Addendum - As Built Changes

PROJECT ADDRESS: 726 CAROLINA AVE
REQUEST TO ADD ADDITIOINAL 110 SQ FT OF LOFT SPACE AND EXTERIOR 2ND FLOOR BALCONY
LOFT OCCUPIES SPACE IN EXISTING FRONT 2-STORY FRONT ENTRY

DATE
					REVISIONS
					BY
					NO.
GOLDWORTH RESIDENCE 726 CAROLINA AVE. SUNNYVALE, CA					
PHILIP GOLDWORTH OWNER/BUILDER					
DATE: 8/11/2016					
SCALE:					
DRAWN:					
JOB:					
SHEET					
Project Data

2 SOUTH SIDE ELEVATION
A-4

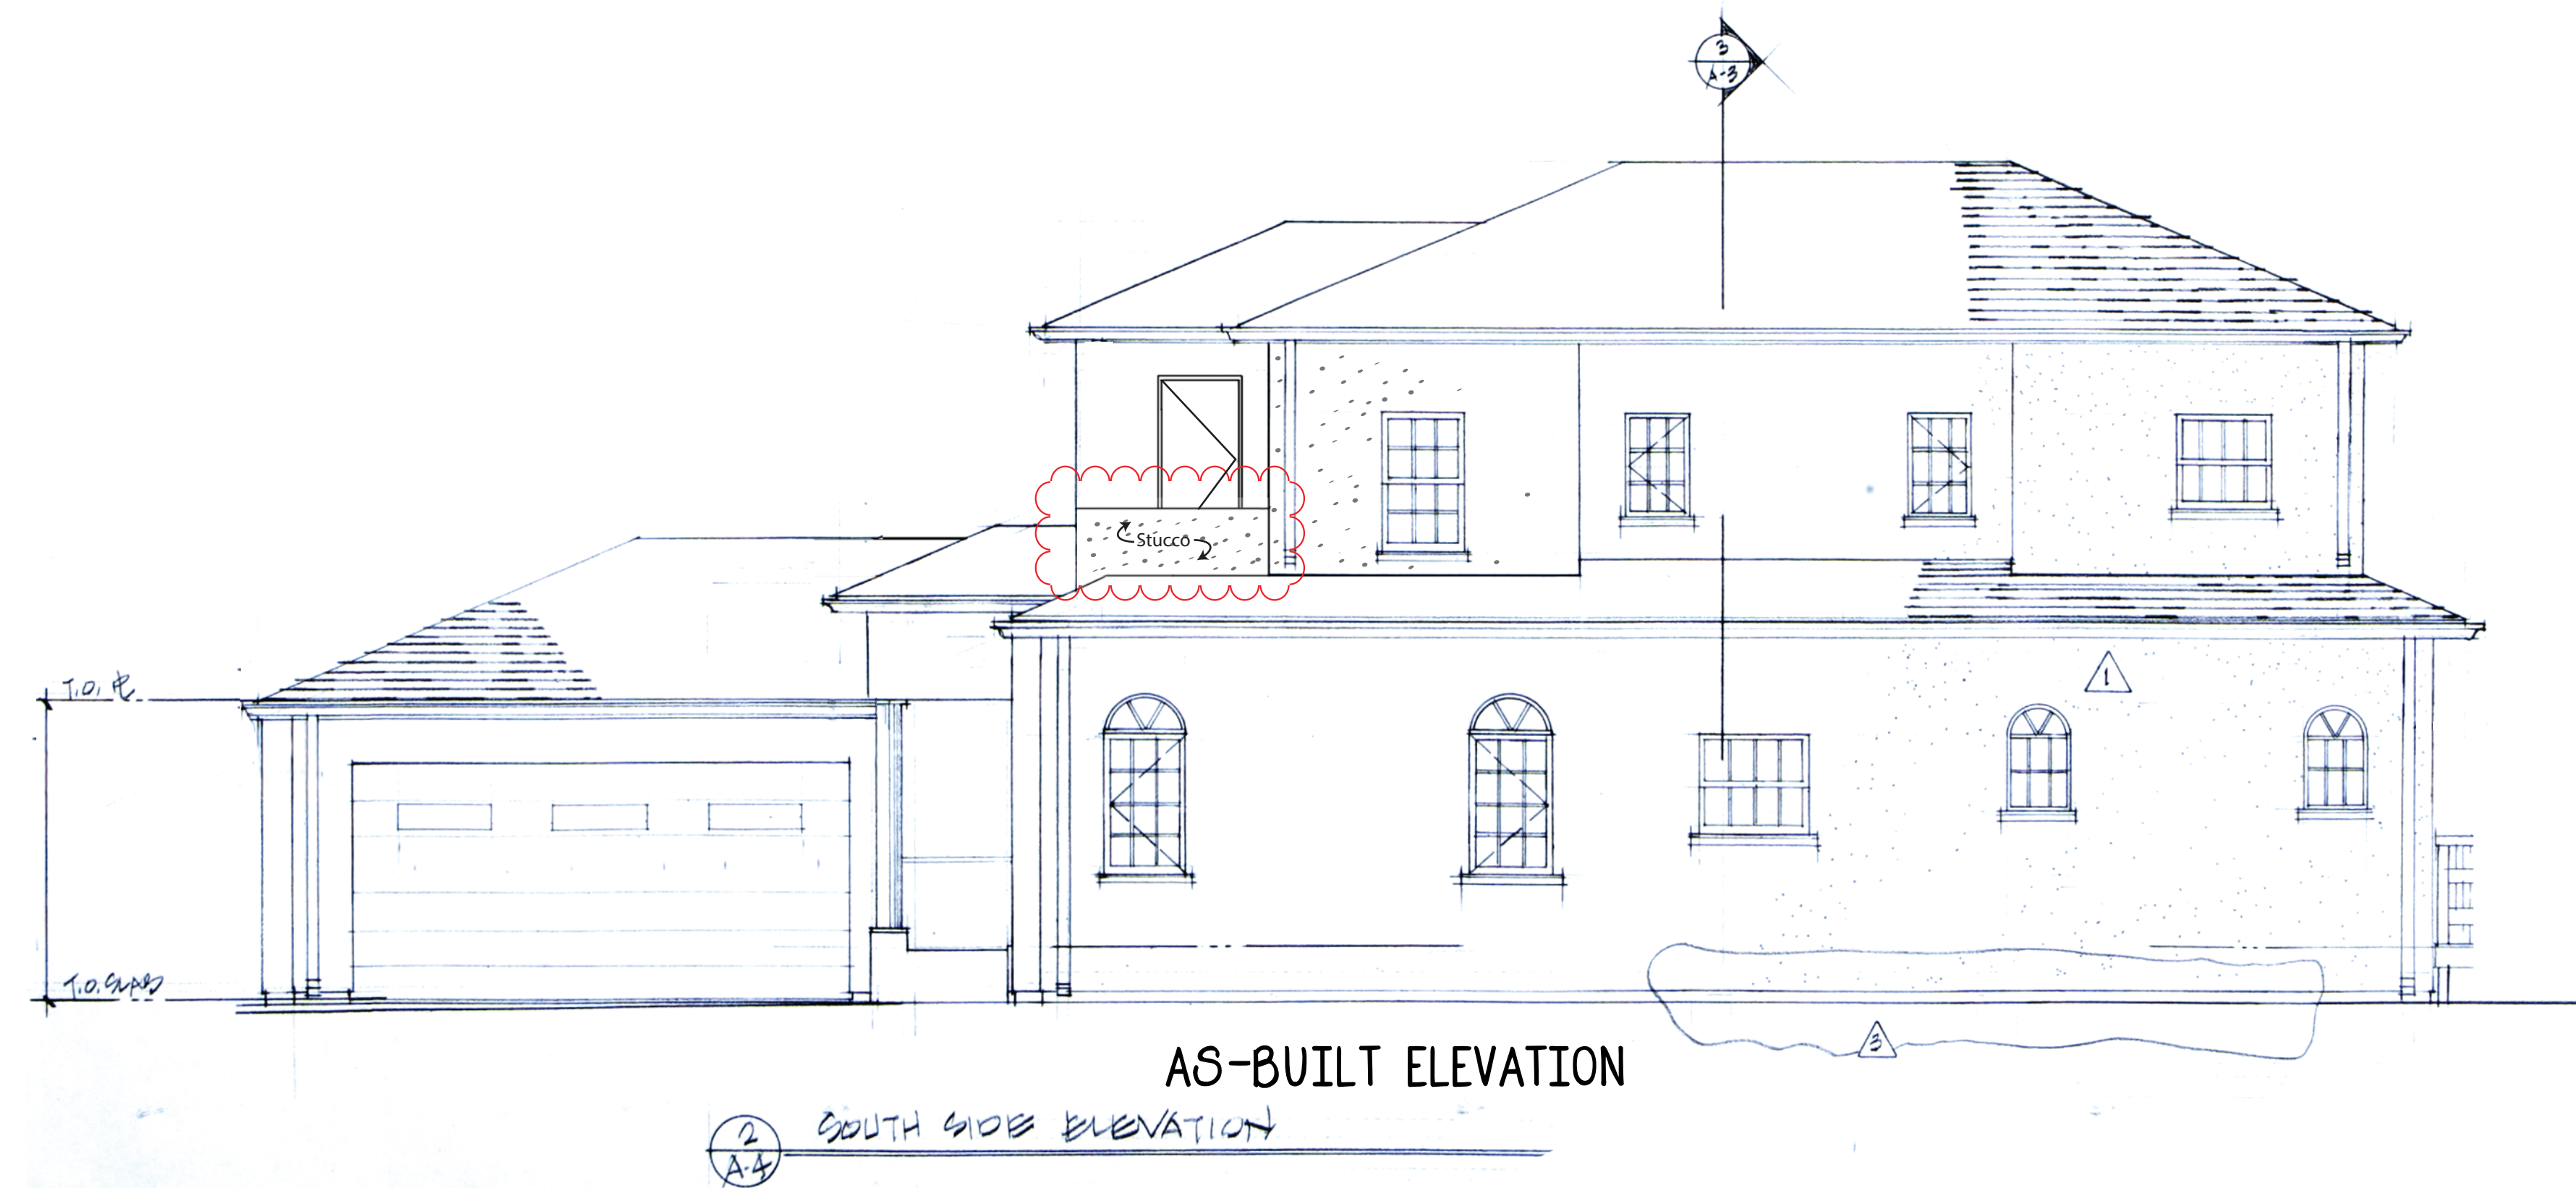
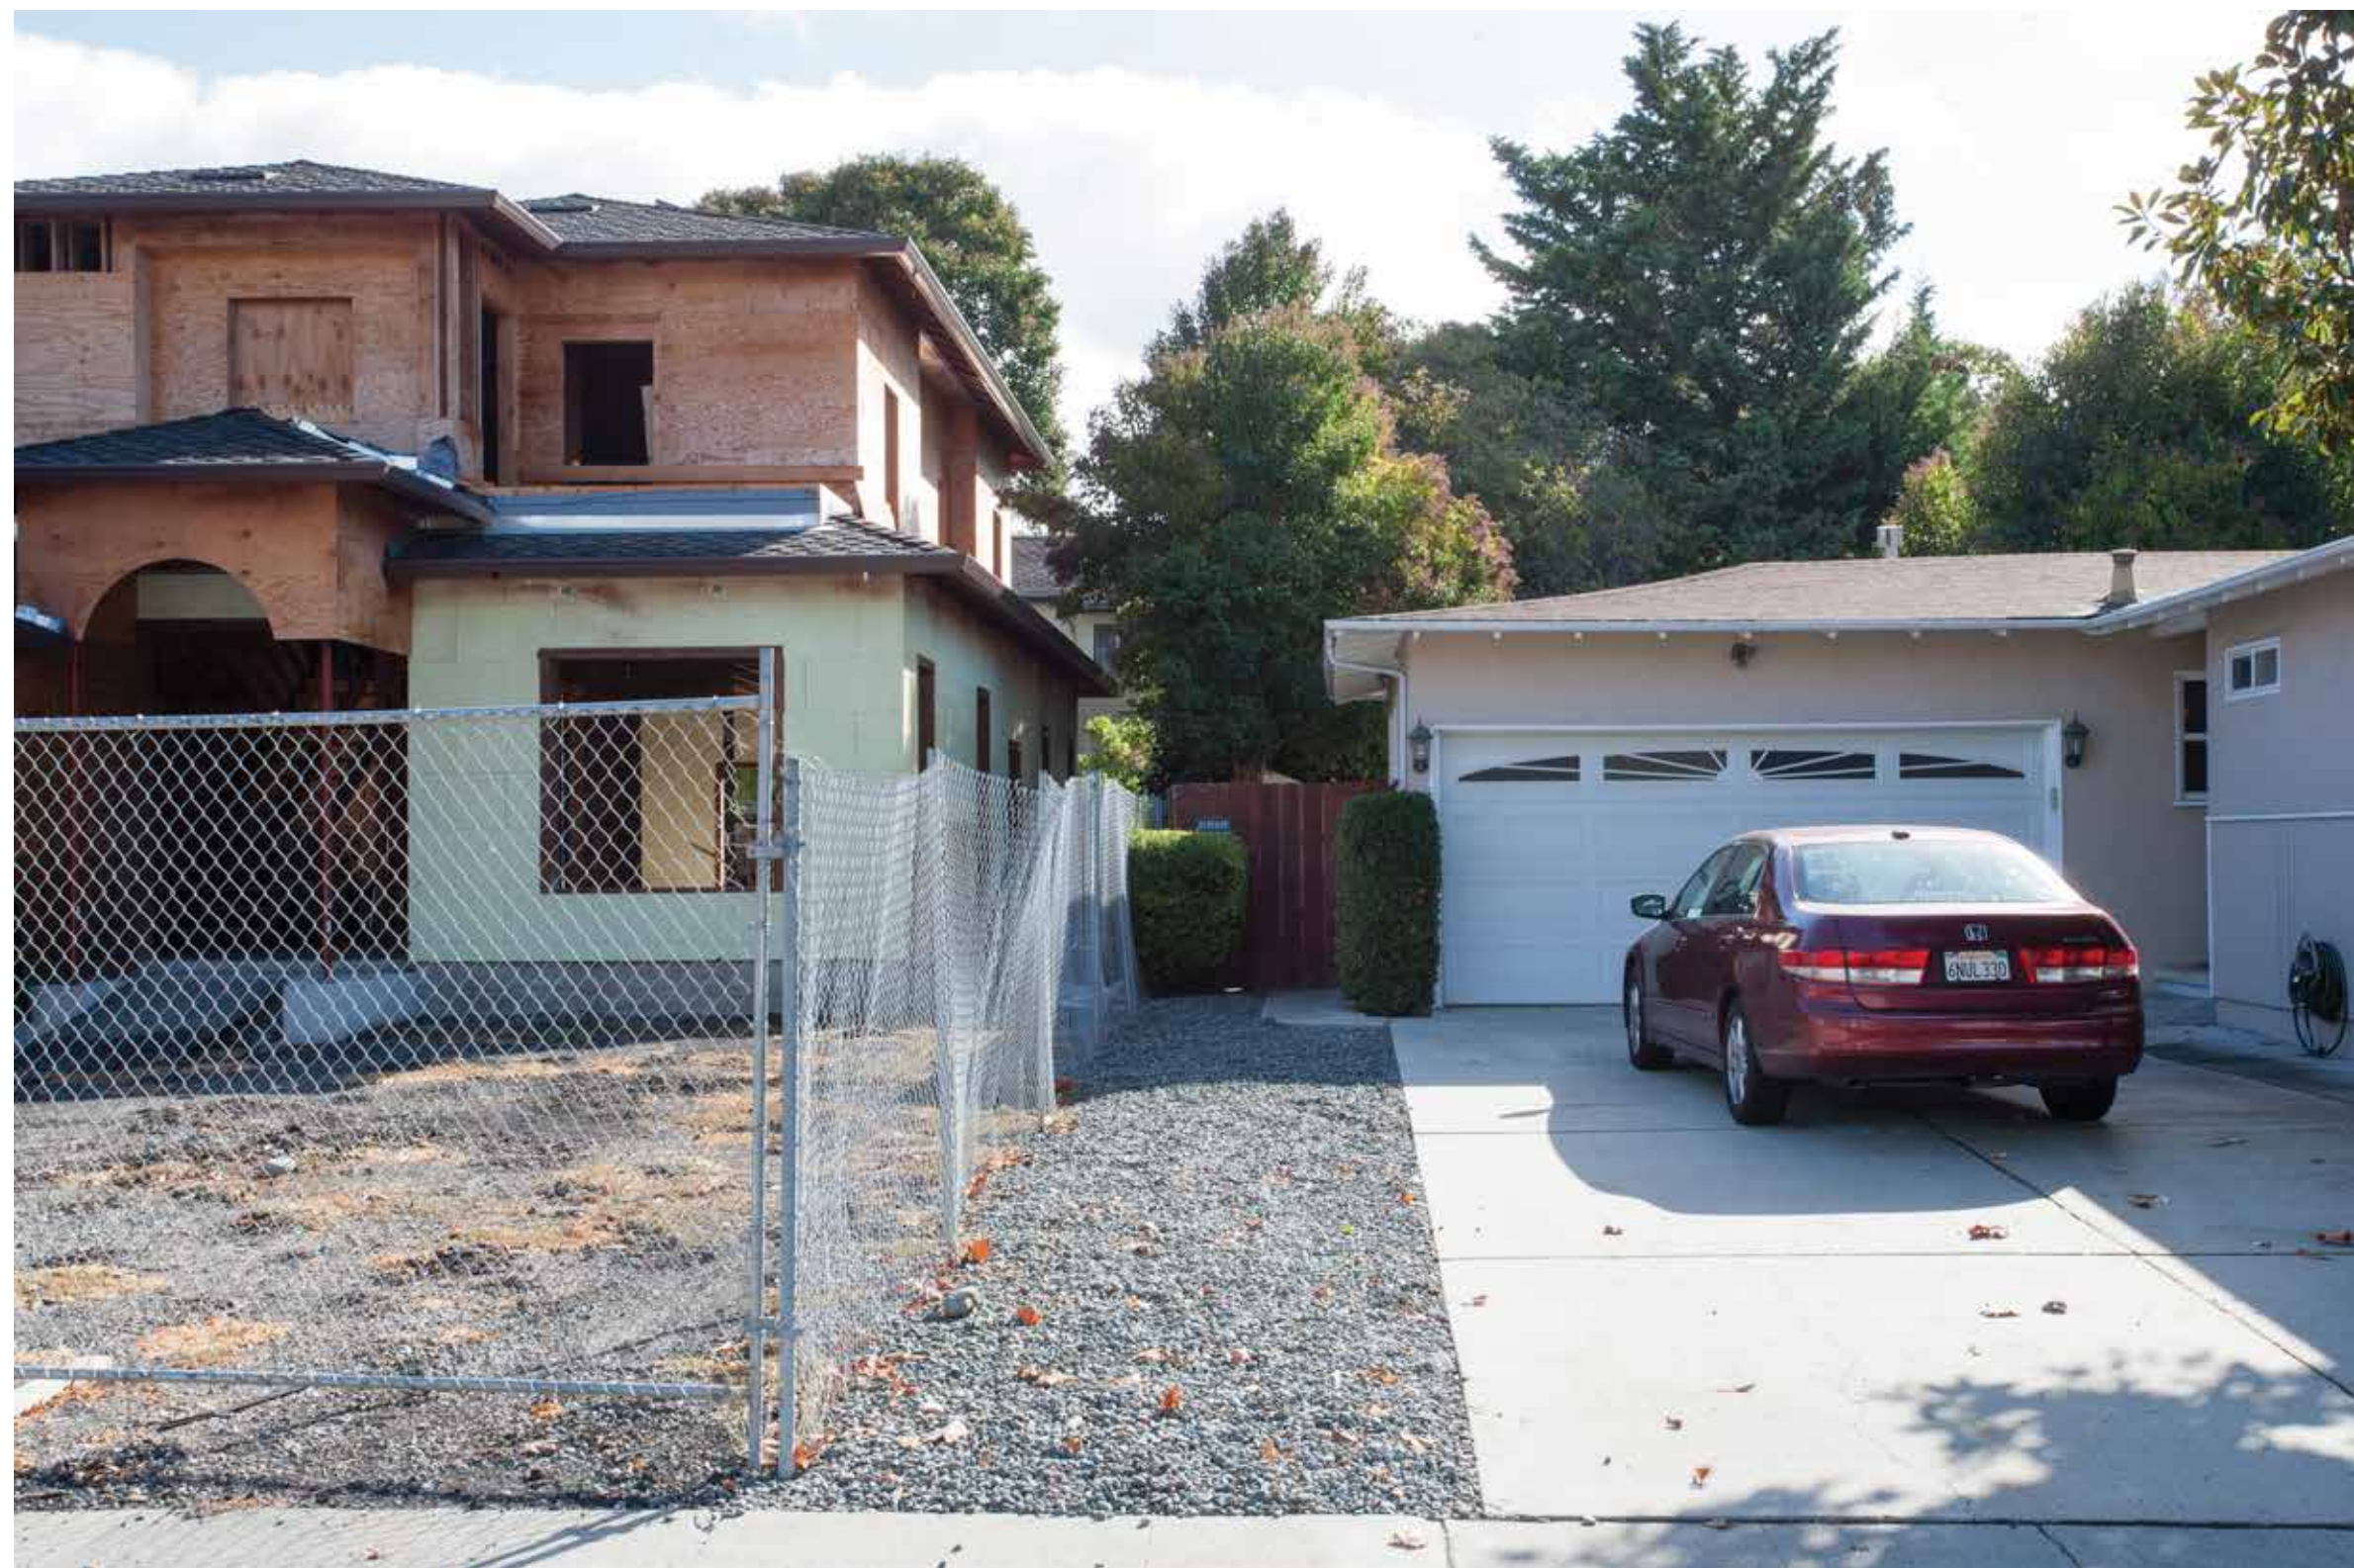
AS-BUILT ELEVATION
